# Technical Service Information

## **FORD 4R44E/4R55E ERRATIC OR NO LINE PRESSURE RISE**

Figure 2

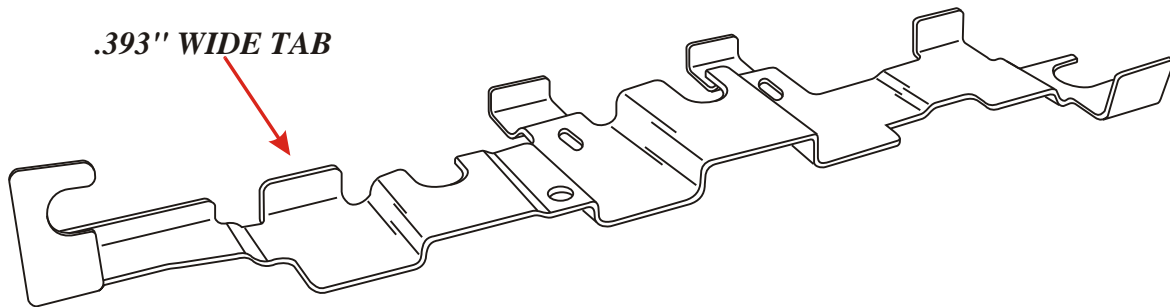
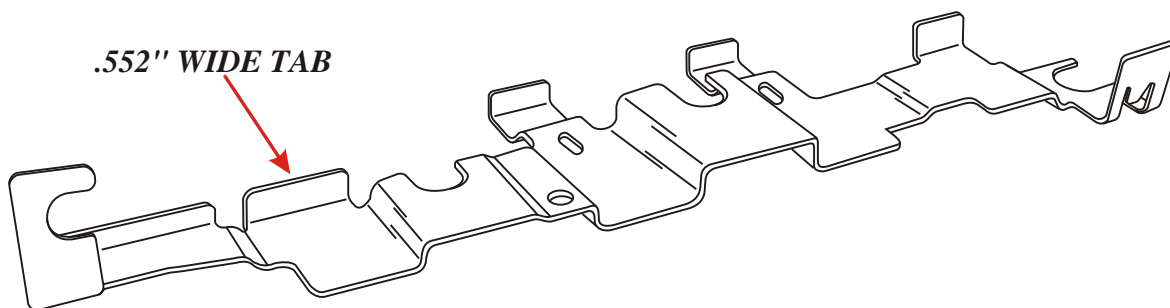
**CAUSE:** The cause may be the EPC solenoid has blown out of the valve body due to a broken solenoid retaining bracket, holding in the EPC solenoid.

## ***PREVIOUS DESIGN RETAINER***

## ***NEW DESIGN RETAINER PART NUMBER XL2Z-7L491-AA***

**CORRECTION:** Replace the early style solenoid retaining bracket, with the new design retaining bracket, as shown in Figures 1 & 2.

Solenoid Retaining Bracket (New Design) .....XL2Z-7L491-AA
